May 26, 2017

TO : All Bidders
FROM : George M. Wiens
PROJECT : CTE Classroom Addition
1615400.41
SUBJECT : Addendum 1
DSA : 04-115755 / 33-H18

DETAILS
DRAWING NUMBER: **M4-1**

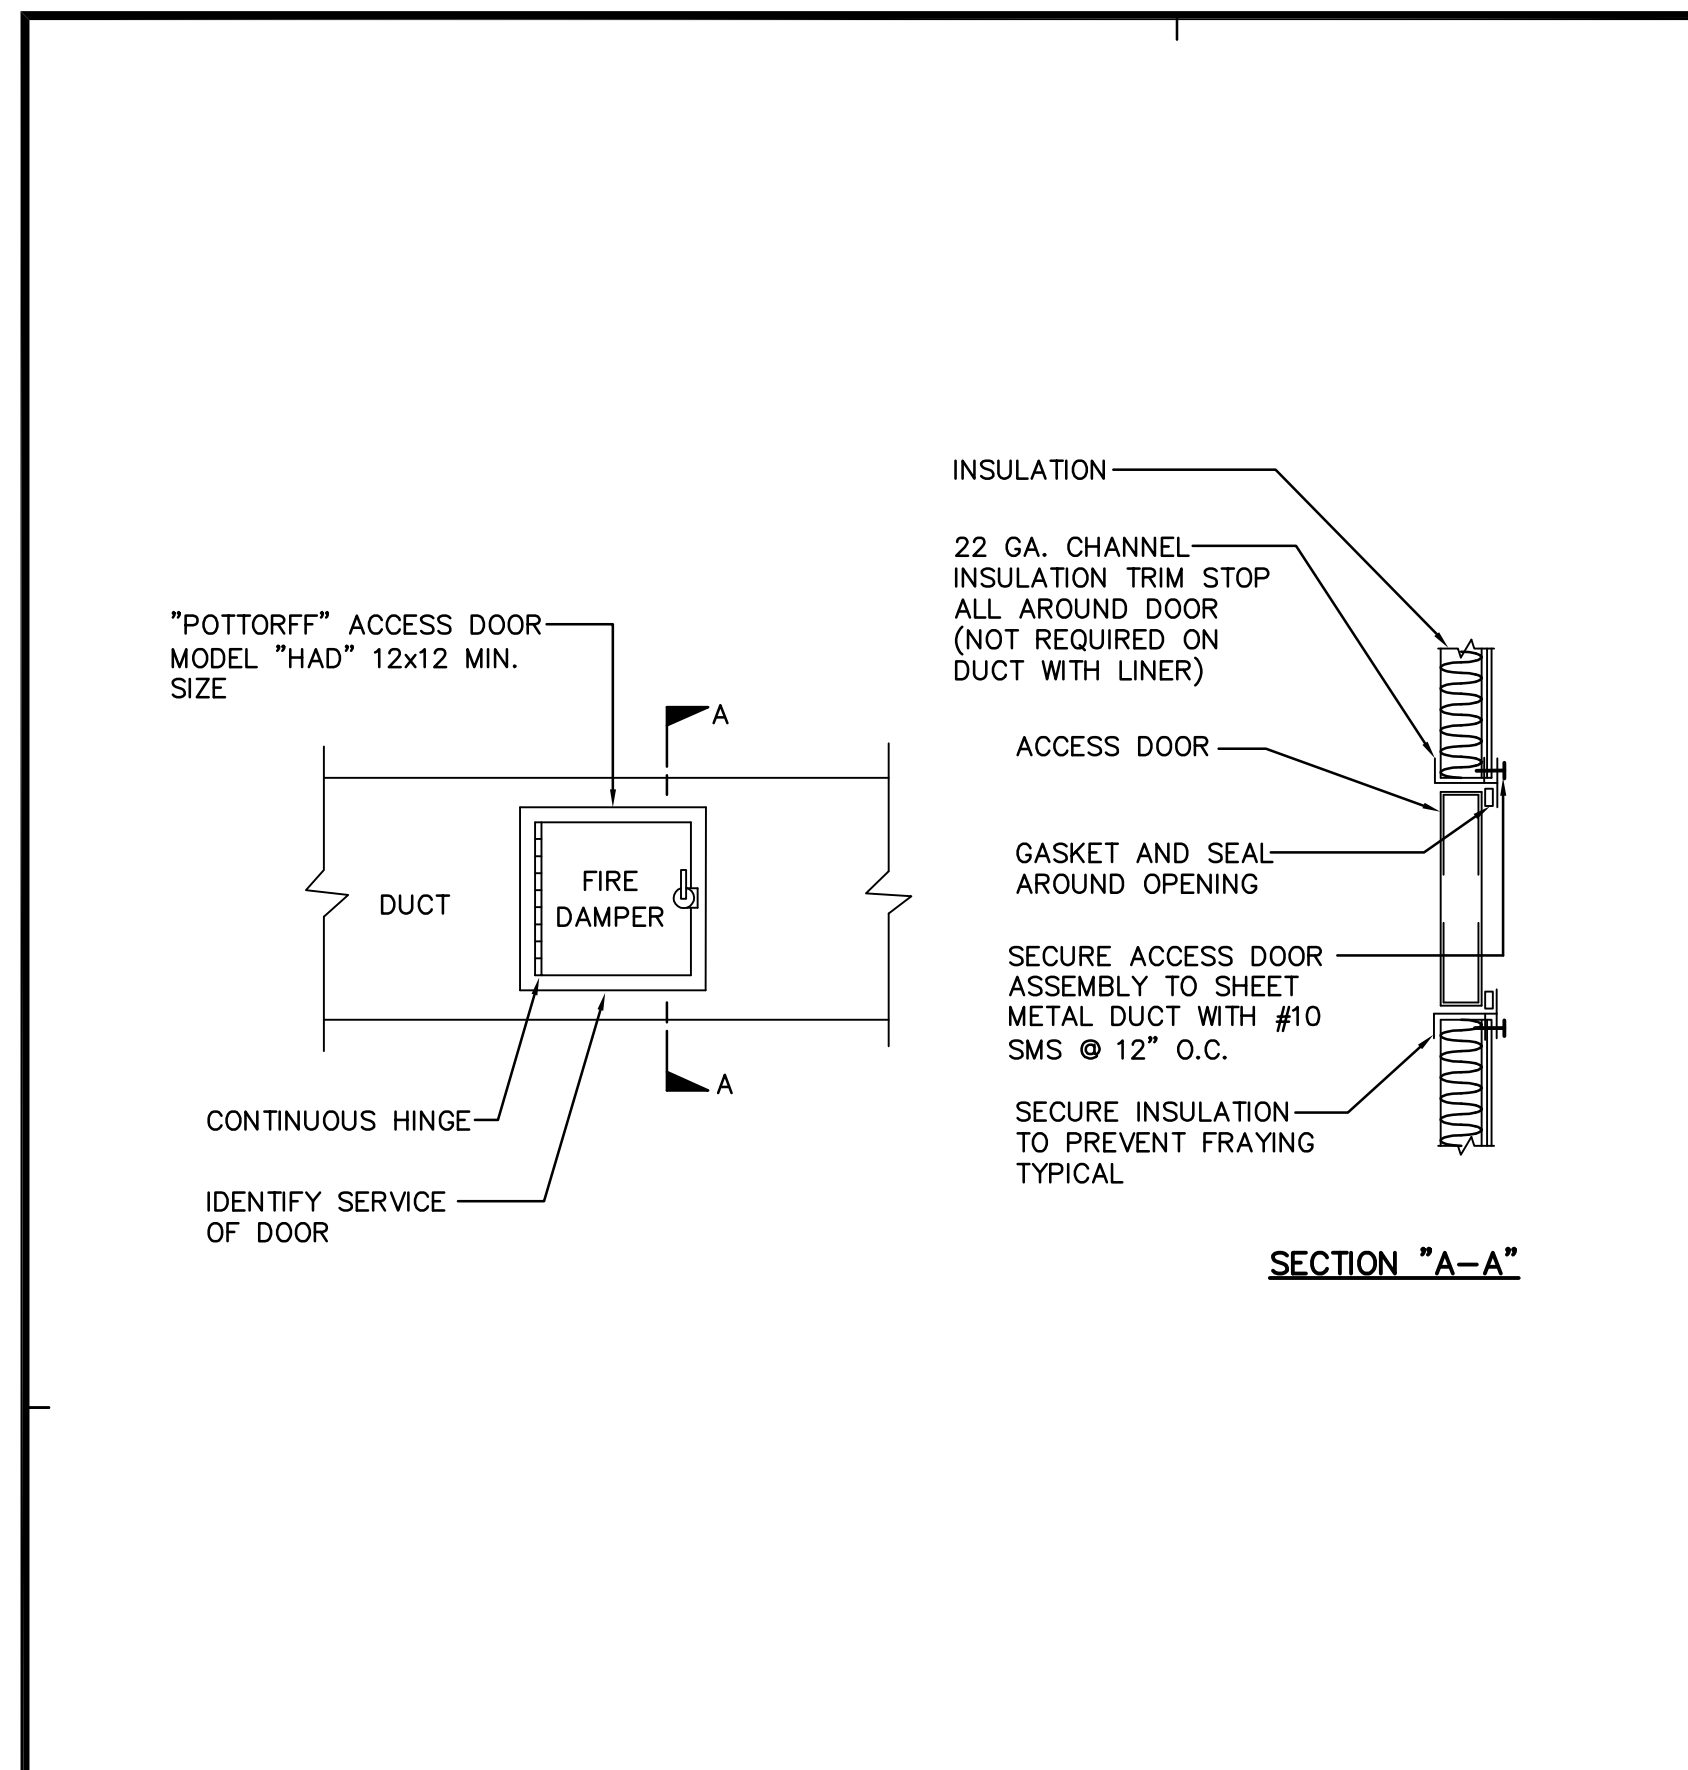
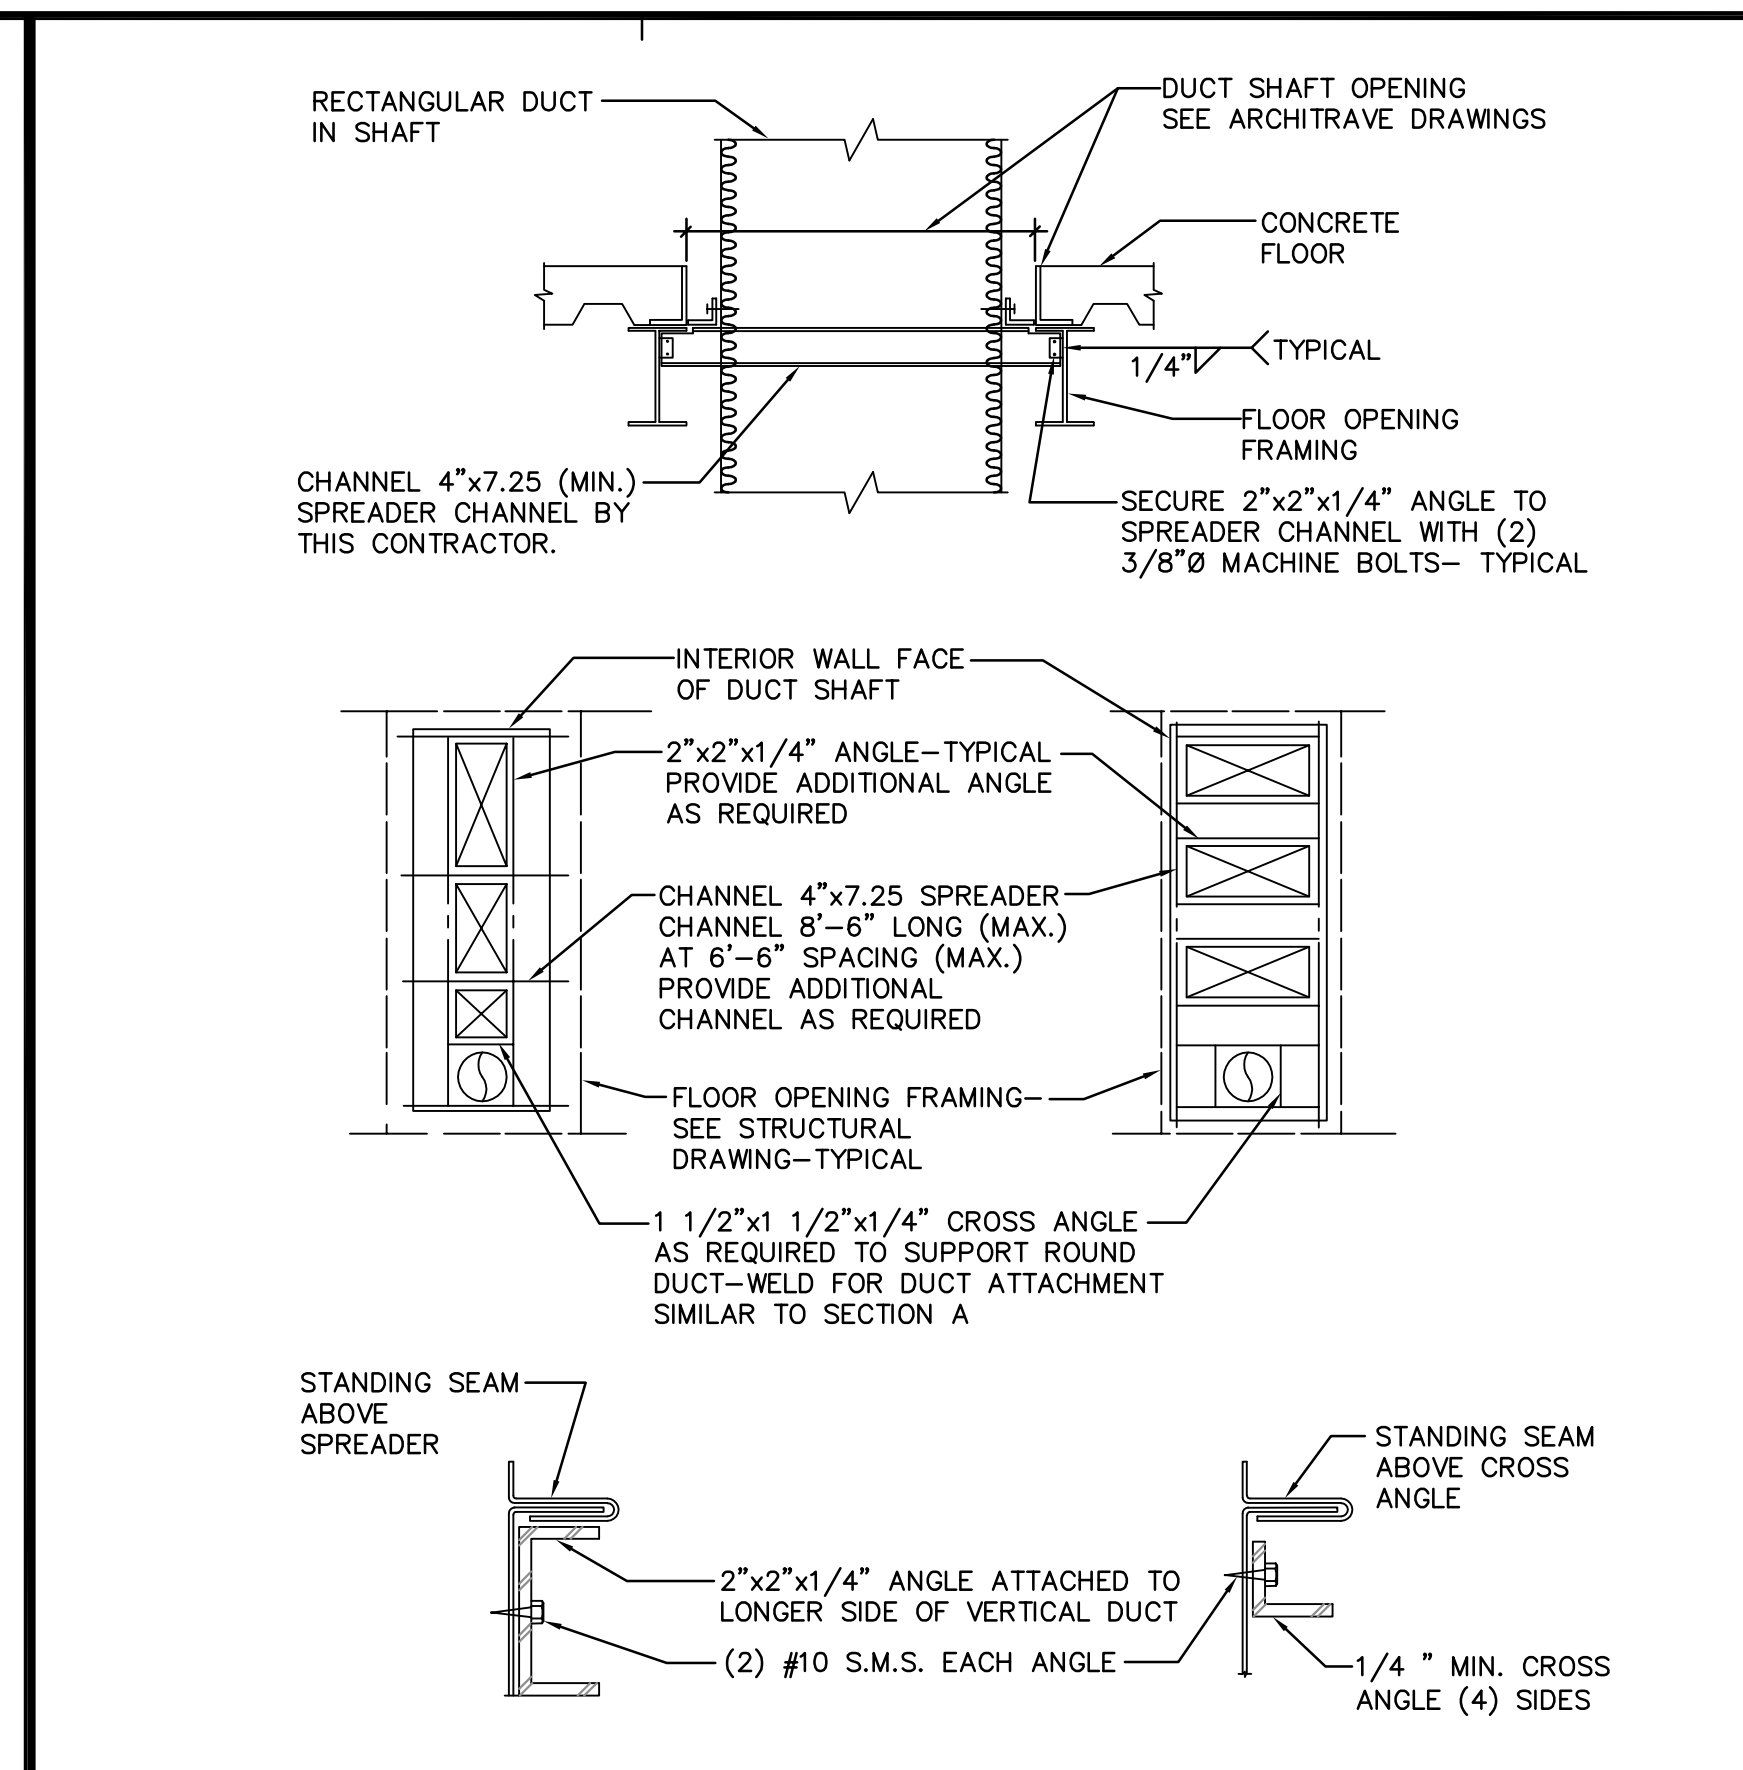
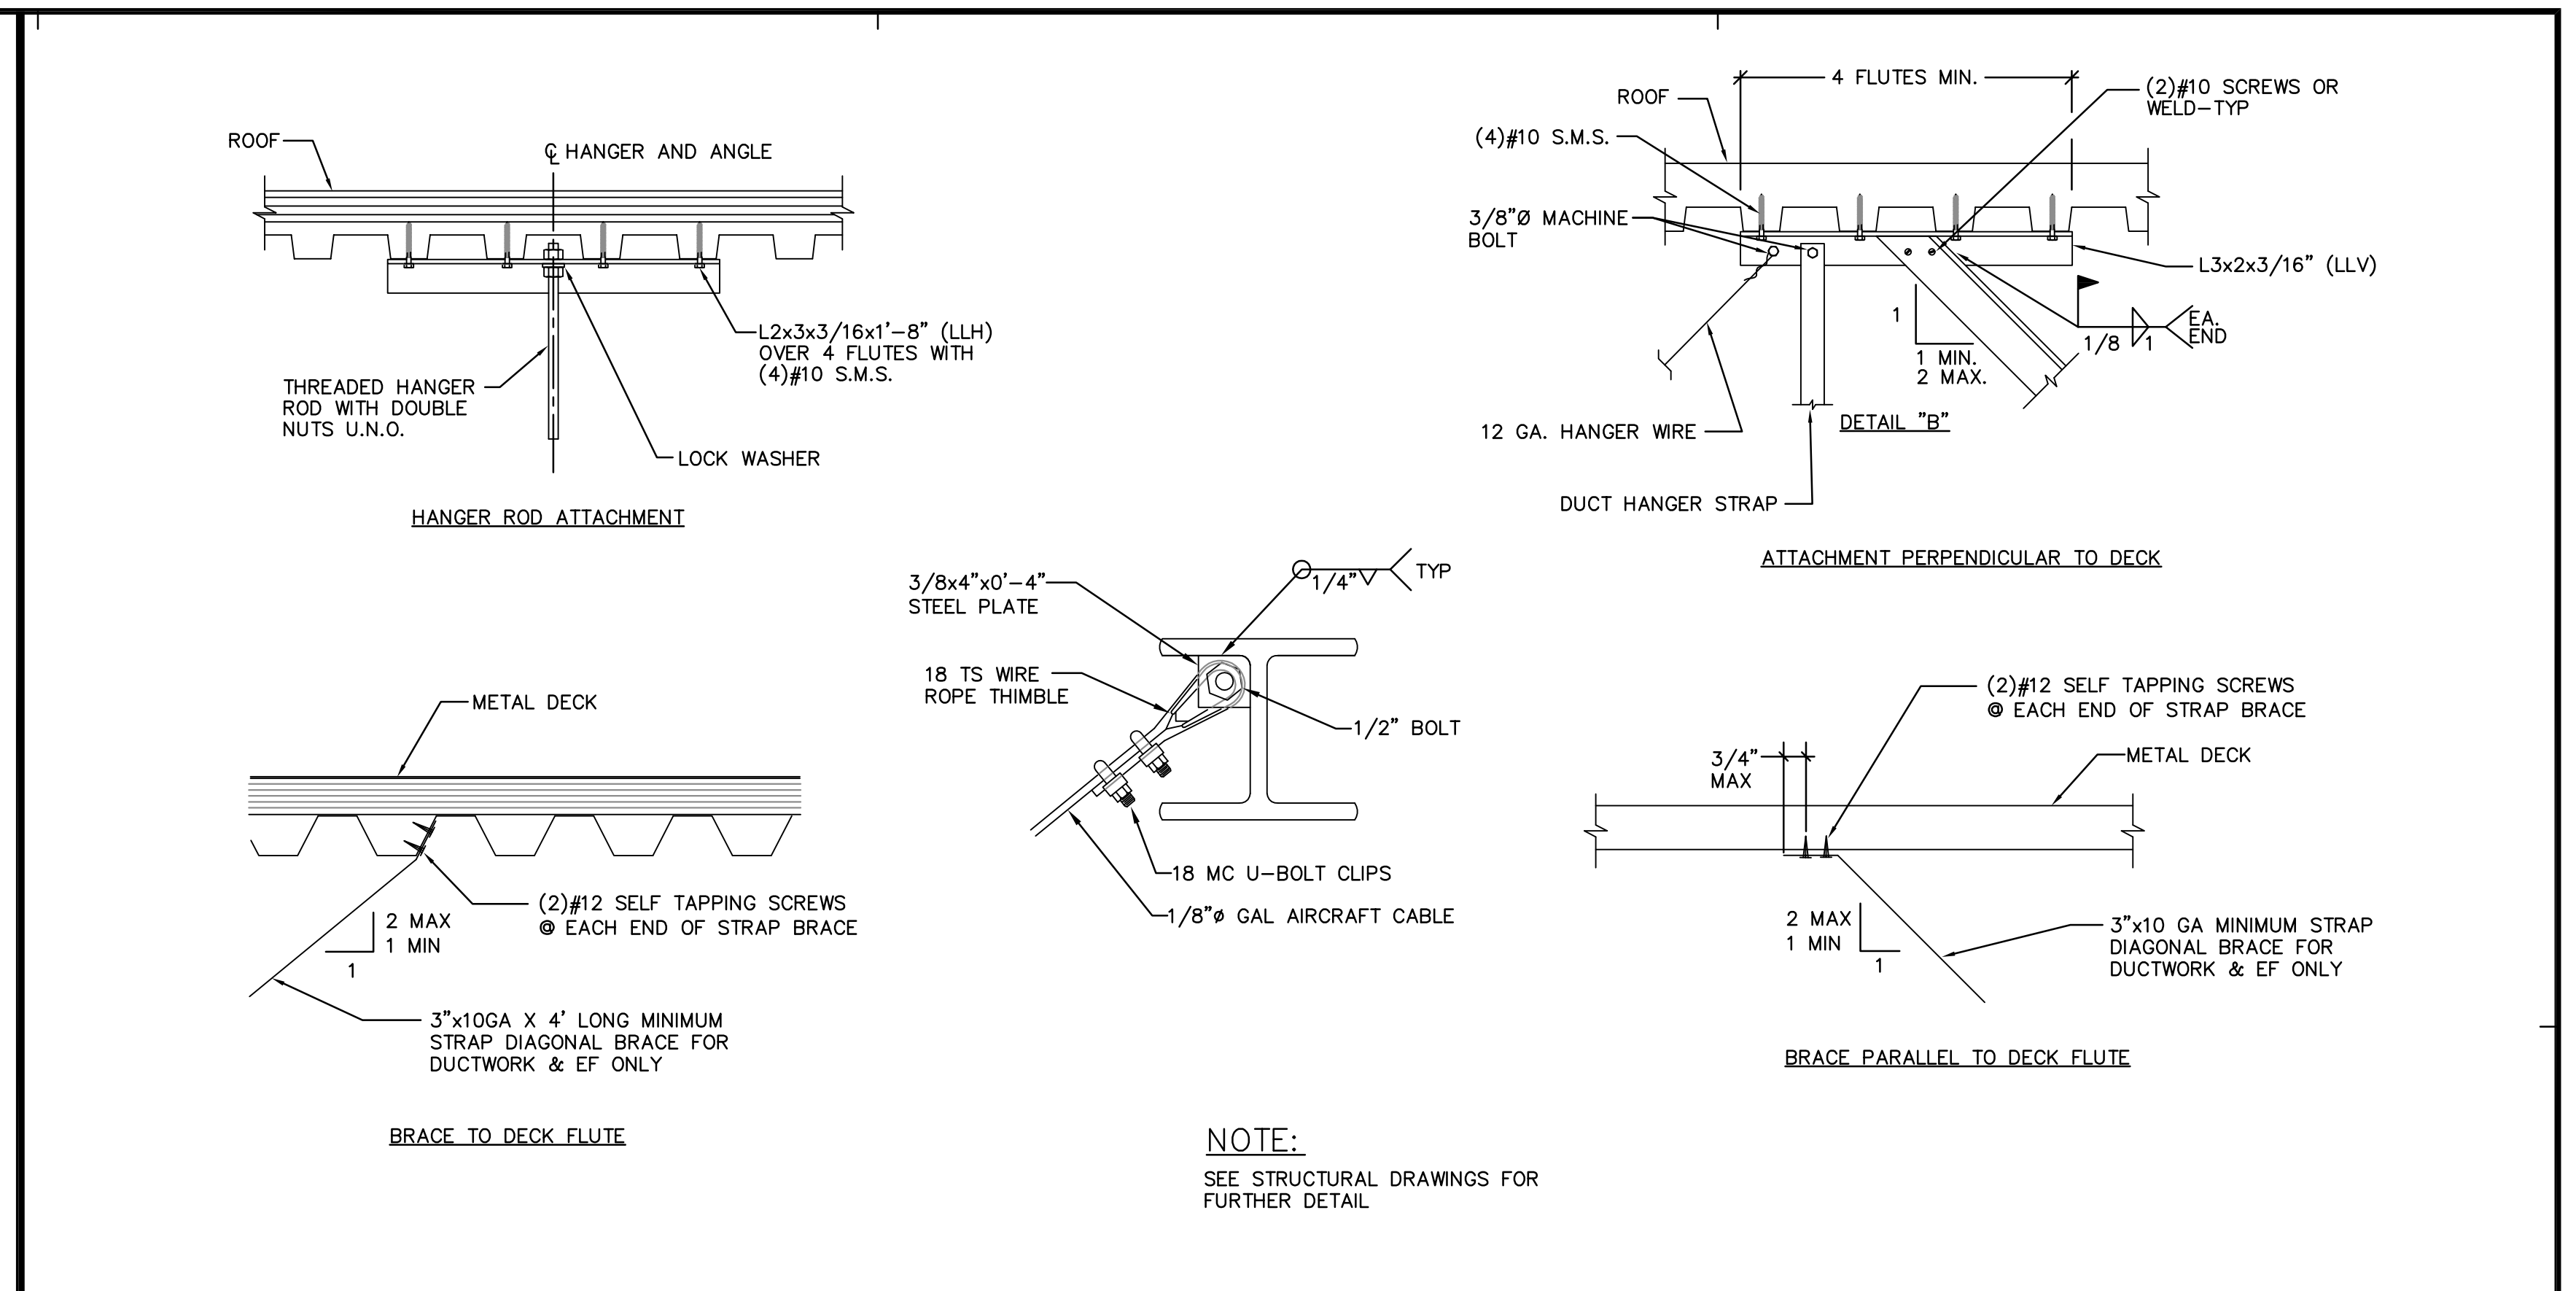
- A. Revise as indicated in the clouded area labeled Delta 1 on the attached M4.1.
